**METROPOLITAN GOVERNMENT OF NASHVILLE AND DAVIDSON COUNTY**

**STAFF RECOMMENDATION**  
**315 South 17<sup>th</sup> Street**  
**September 16, 2015**

**Application:** New construction—Infill and outbuilding  
**District:** Lockeland Springs-East End Neighborhood Conservation Zoning Overlay  
**Council District:** 06  
**Map and Parcel Number:** 08314025500  
**Applicant:** Van Pond Architect, PLLC  
**Project Lead:** Paul Hoffman, paul.hoffman@nashville.gov

**Description of Project:** New construction of a two-family residence and detached outbuilding.

Figure 1. Existing non-contributing structure

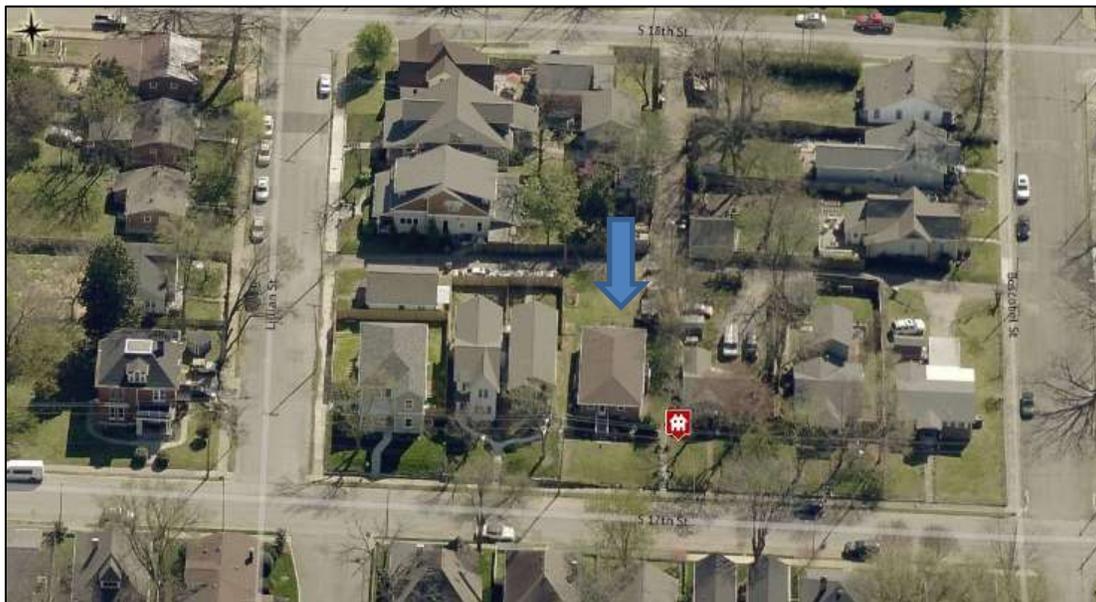
**Demolition:** The existing building on the site is a brick-veneered home constructed circa 1976. It is not a contributing building due to its date of construction, use of materials, form and context. A small shed will also be demolished. Staff finds that neither the principal structure nor the outbuilding are contributing to the architectural and historical character and significance of the district, and that their demolition meets Section III.B.2 for appropriate demolition and does not meet section III.B.1 for inappropriate demolition.

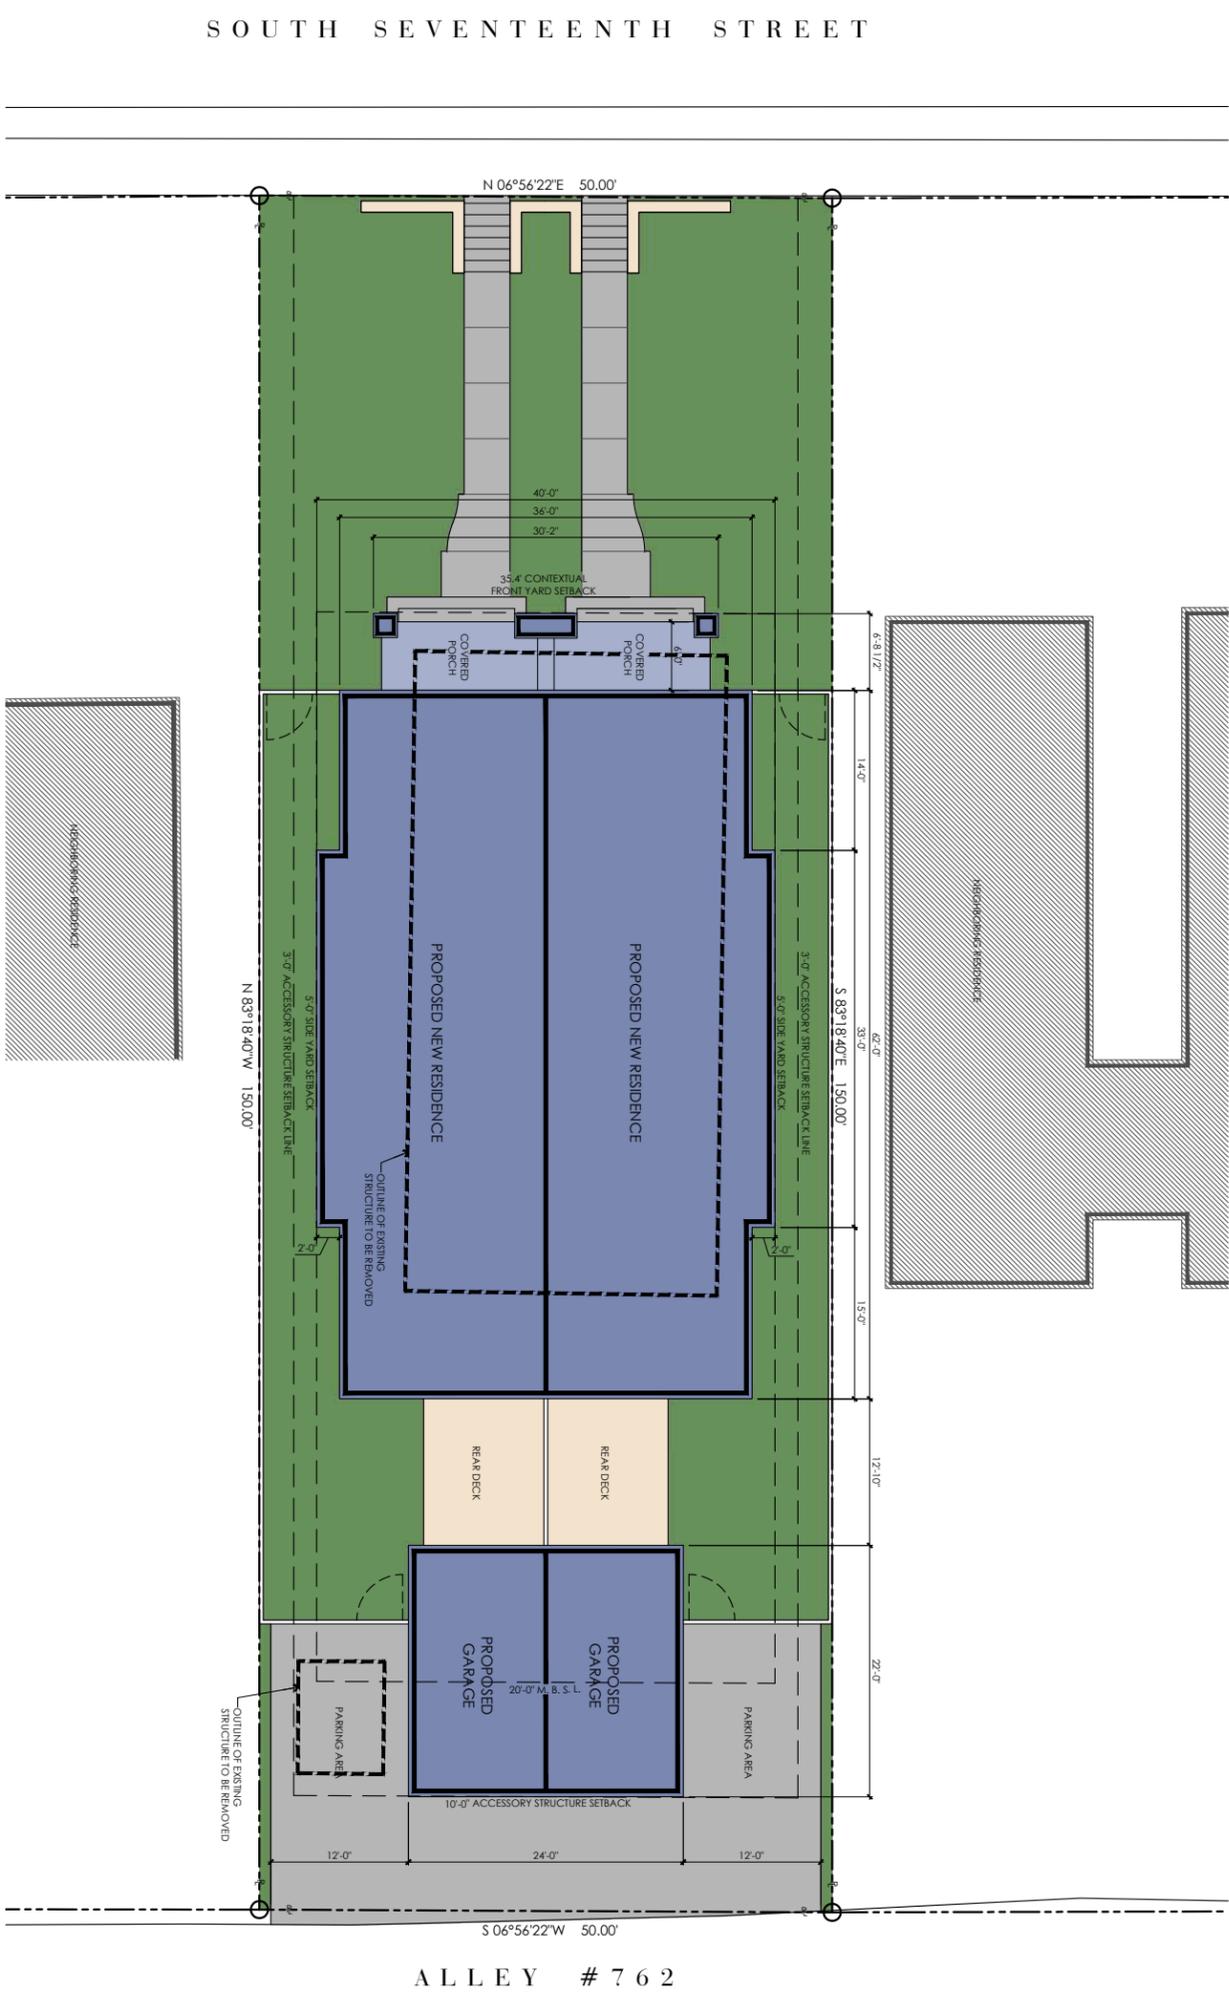
PROPOSED	MINIMUM
Space between principal building and DADU/Garage	12’10”	20’
Rear setback	10’	3’
L side setback**	12’	3’
R side setback**	12’	3’
How is the building accessed?	Alley	From the alley or existing curb cut

**2** Side (North) Elevation - South Elevation Mirrored

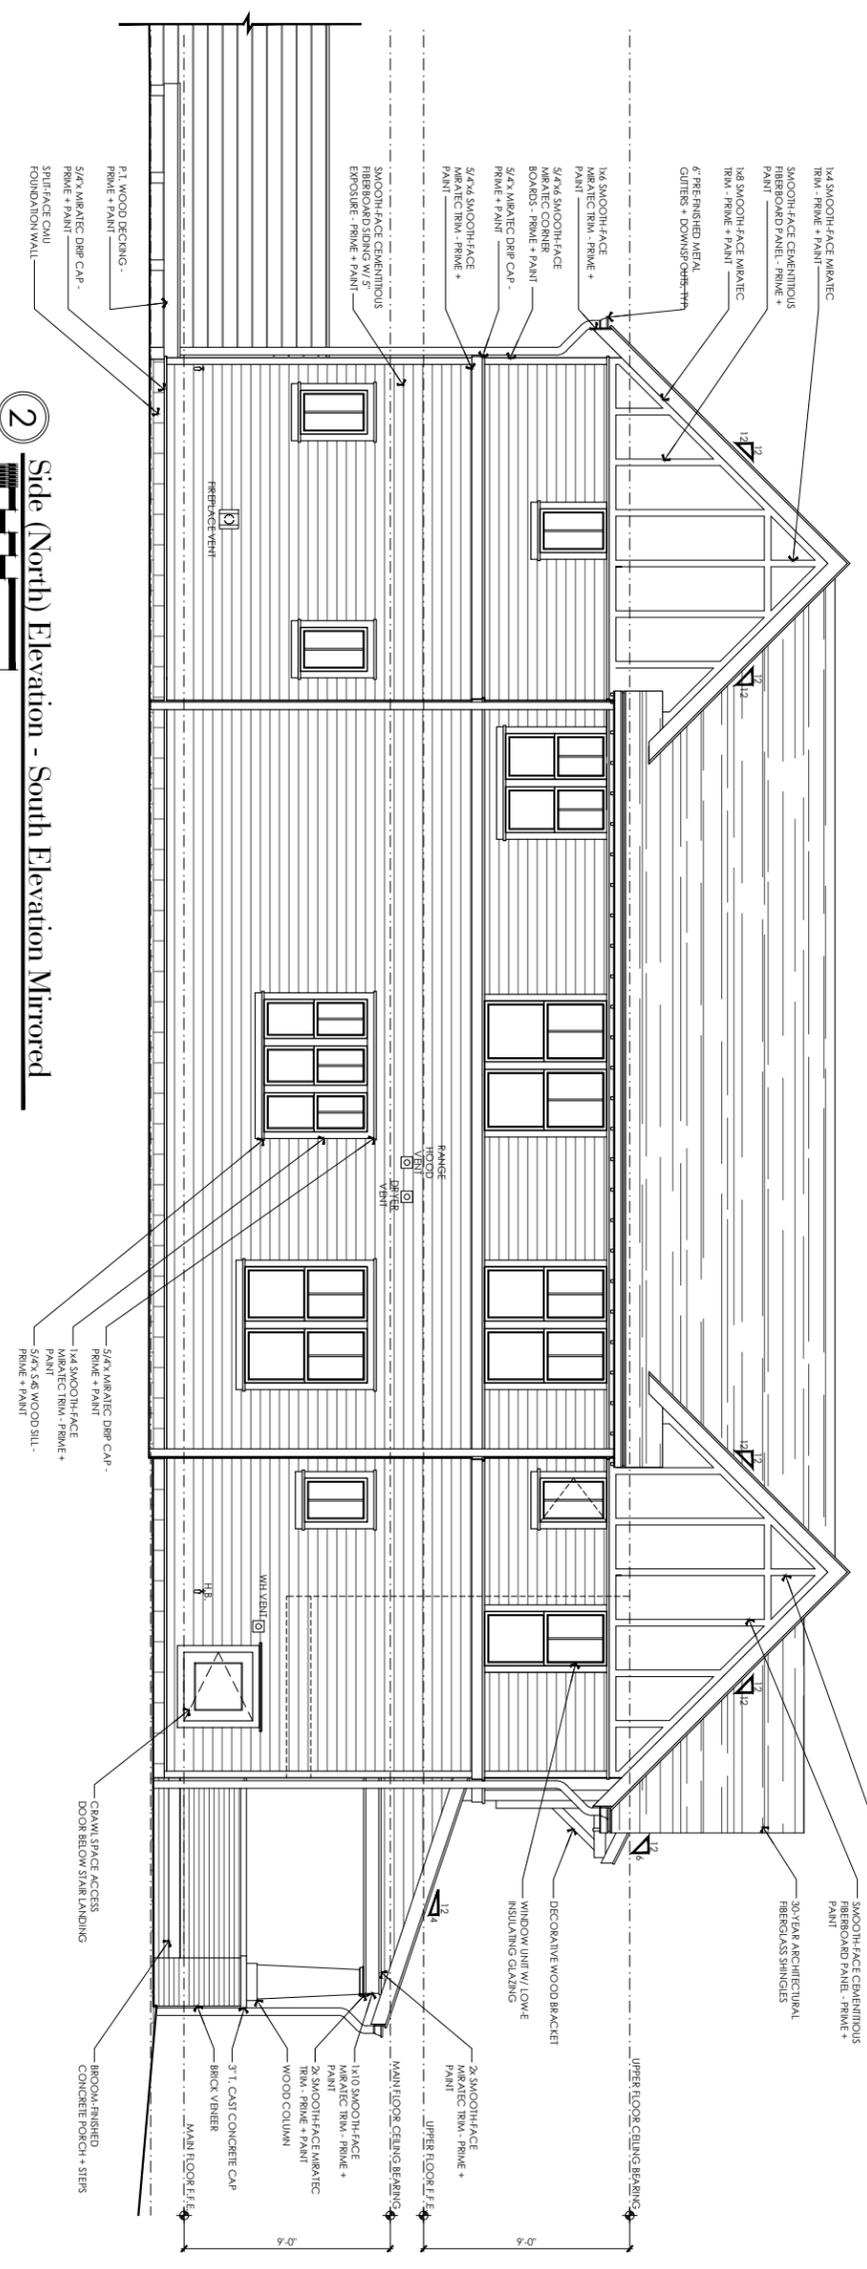
Proportion and Rhythm of Openings: The windows on the proposed infill are generally twice as tall as they are wide, thereby meeting the historic proportions of openings. Paired windows have a four inch to six inch (4"-6") mullion between them. At the front of each side elevation, there is approximately twelve feet (12') of wall area without an opening; Staff recommends the addition of a window opening in this area to break up that wall area. With an additional window opening here, Staff finds the project's proportion and rhythm of openings to meet Section II.B.7.

1. The drawings be resubmitted to show the true height based on the grade and that the building not exceed thirty-four feet (34') from the front finished grade;
2. A window opening be added to each side elevation, in the front entry hall;
3. The finished floor height shall be consistent with the finished floor heights of the adjacent historic houses, to be verified by MHZC staff in the field;
4. Staff approve the final details, dimensions and materials of windows and doors prior to purchase and installation;
5. The HVAC shall be located behind the house or on either side, beyond the mid-point of the house; and
6. Staff approve the roof color and masonry color, dimensions and texture.
